Re: (RE: Re: (RE: Building Dispute MB # 050417))

In short, I requested thermally broken aluminum sliding doors (which have an adjacent window) for reducing condensation on the aluminum frames. However, I found they are partially non-thermally broken after the installation. Afterward, I was informed they are not able to provide us with fully thermally broken aluminum sliding doors and then the builder (i.e. JSR Construction) and the supplier (i.e. Hagley Windows & Doors) agreed to change parts of the non-thermally broken members (i.e. stiles) without full warranty and without my agreement. And also, they refuse to change a partially non-thermally broken member (i.e. fixed interlocker). If I was informed of the known manufacturer's issues and the warranty condition before the order, I would not have made this order. I do not accept that the sliding doors are not fully thermally broken and do not have full warranty. I require the builder to replace and reinstall the whole entire partially thermally broken sliding doors (with adjacent window) all to functional thermally broken sliding doors (with adjacent window) with full warranty and also accept any liabilities that may arise such a

Figure 1 - Photo location plan

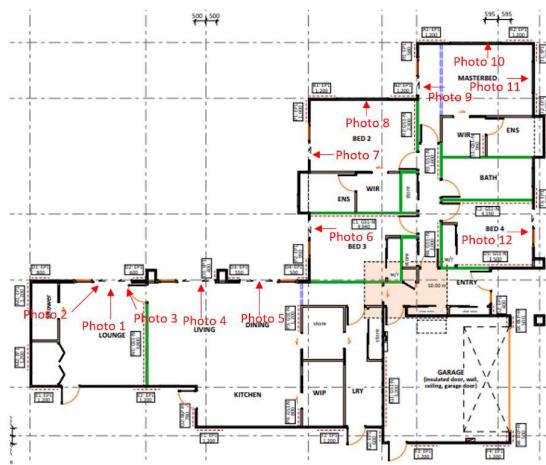
- 1) The parts of the windows and doors frames do not have the thermally broken strip. These windows and doors make up 59% of the area of all the aluminium joinery products. The total area of these problematic aluminium joinery is 28.8 m sq. The total area of all aluminium joinery products is 48.6 m sq. These problematic products are shown in the following photos (note that the photos and the location plan are given at the end of this email):

Photo 1: Path of thermal conduction at the joint of window transom and sliding-door fixed interlocker and the same photo without marking is given side by side for easy reference

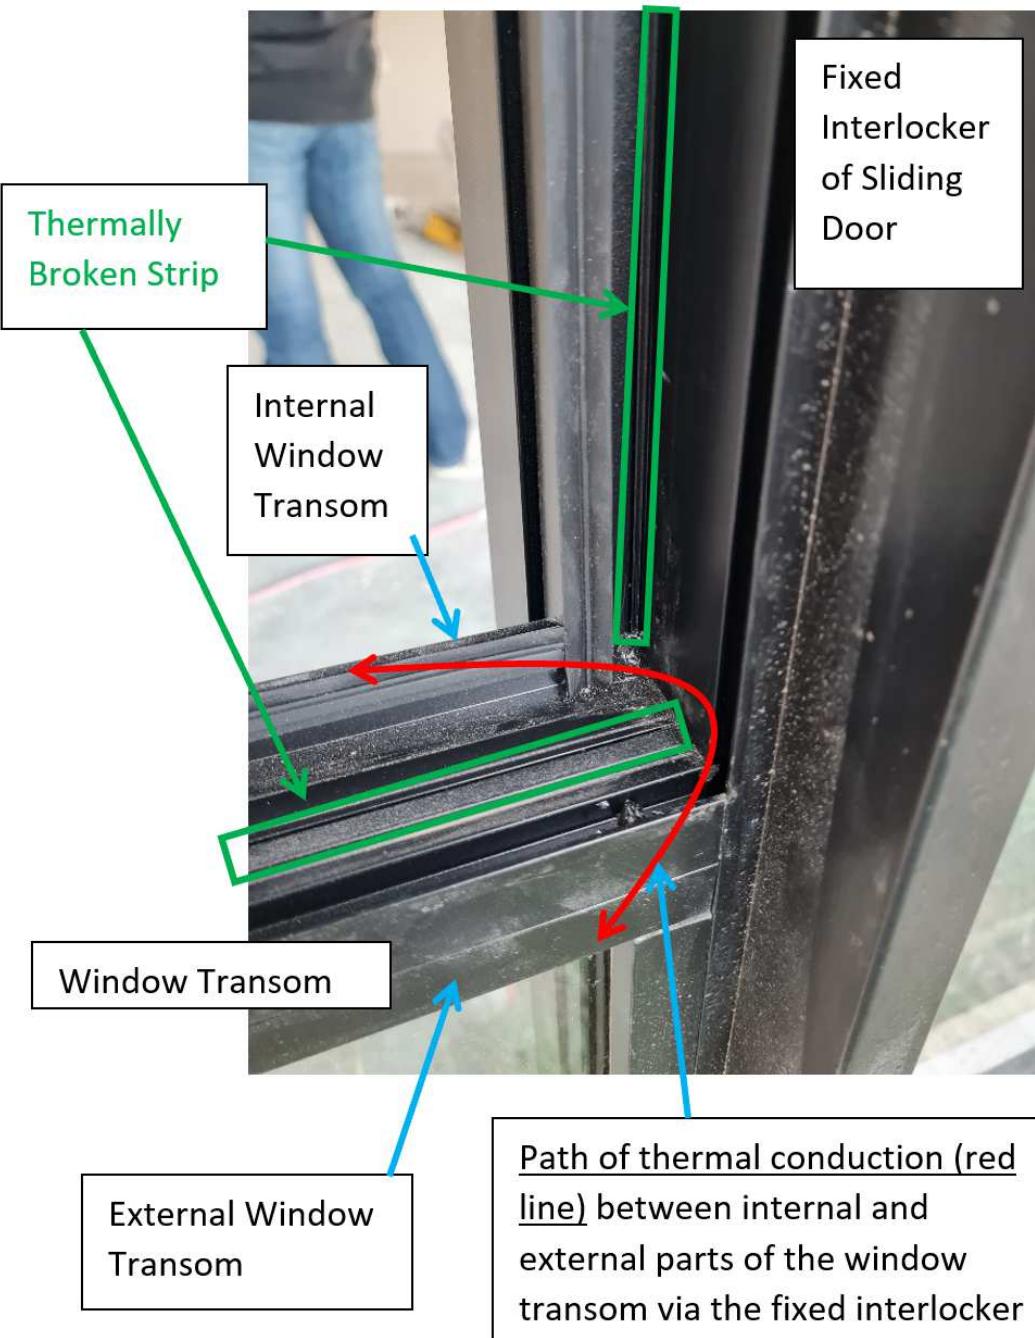
1. You shall replace all non-thermally broken components of the sliding doors and windows which including but not limited to the stiles and fixed interlocker. There is a path of thermal conduction where it is not thermally broken at the joint of the window transom and sliding-door fixed interlocker as indicated by the red line on the marked photo as shown on Photo 1 below. The same photo without marking is given side by side for easy reference. You are required to change the fixed interlocker to have the proper thermally broken strip align with the strip on the window transom. I also took a thermal image (see Photo 2) with the sunshine reaching half the height of the sliding door. It showed that the non-thermally broken components (the joint in between the interlocker and the window transom, and the stiles) creating a thermal conduction between the internal and external parts of the thermally-broken members (e.g. bottom of the sliding door frames and the window transom).
